**SECTION 16 APPLICATION
TOWN PLANNING ORDINANCE (CHAPTER 131)**

Town Planning Application No. A/YL-NSW/349 - Submission of Further Information (1)

Response-to-Comment Table

**PROPOSED TERMINAL MANHOLE AND
CONNECTION**

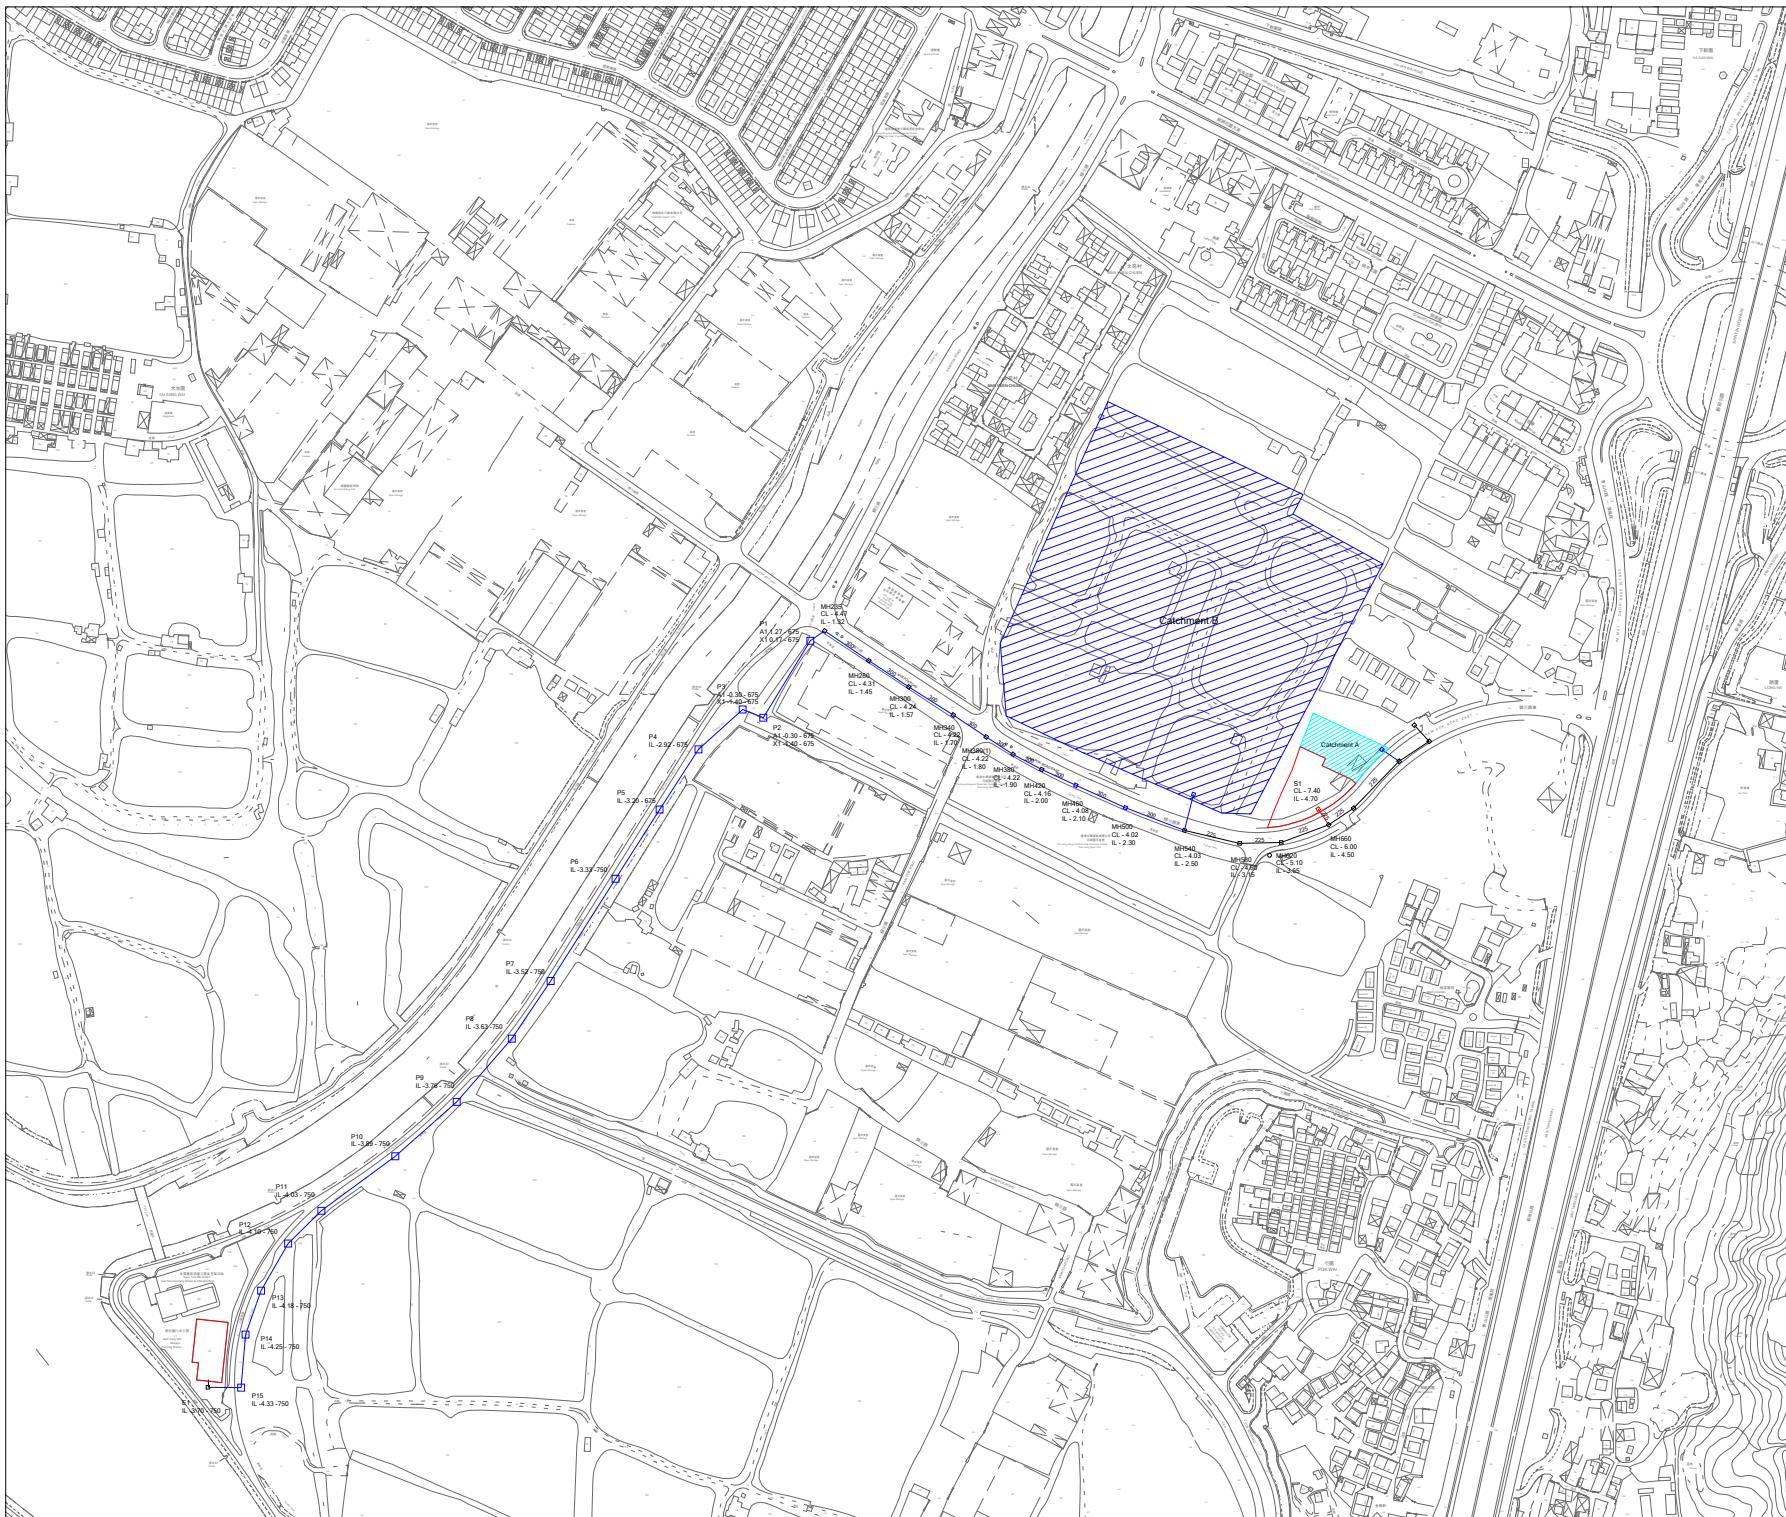
<p>1. Para. 2.2.1 - Please check if the Figure 2 including existing sewerage record;</p>	<p>Figure 2 is supplemented.</p>
<p>2. Para. 2.2.2 - Please review "coube";</p>	<p>The typo is revised.</p>
<p>3. Para. 2.2.2 - Please review "termination" should read "terminal";</p>	<p>The typo is revised.</p>
<p>4. Para. 3.1.2 - Please clearly show the existing sewerage system on drawings for reference;</p>	<p>The existing sewerage system is indicated in Figure 3.</p>
<p>5. Please advise who will implement and maintain the proposed sewerage system/facilities. Please discuss in the report text and prepare a drawing for comment; and</p>	<p>Figure 3 is updated to include liability of implementation and maintenance. Detailed discussion refer to Para 2.2.2 and 2.2.3.</p>
<p>6. Figure 3 - Please indicate all cover levels. Please note that the cover level(s) of terminal manhole(s) should be higher than that of the downstream public manhole(s). Please include the above in report text and drawing remark.</p>	<p>The cover levels has included in Figure 3. Report text is provided in Para.2.2.3.</p>
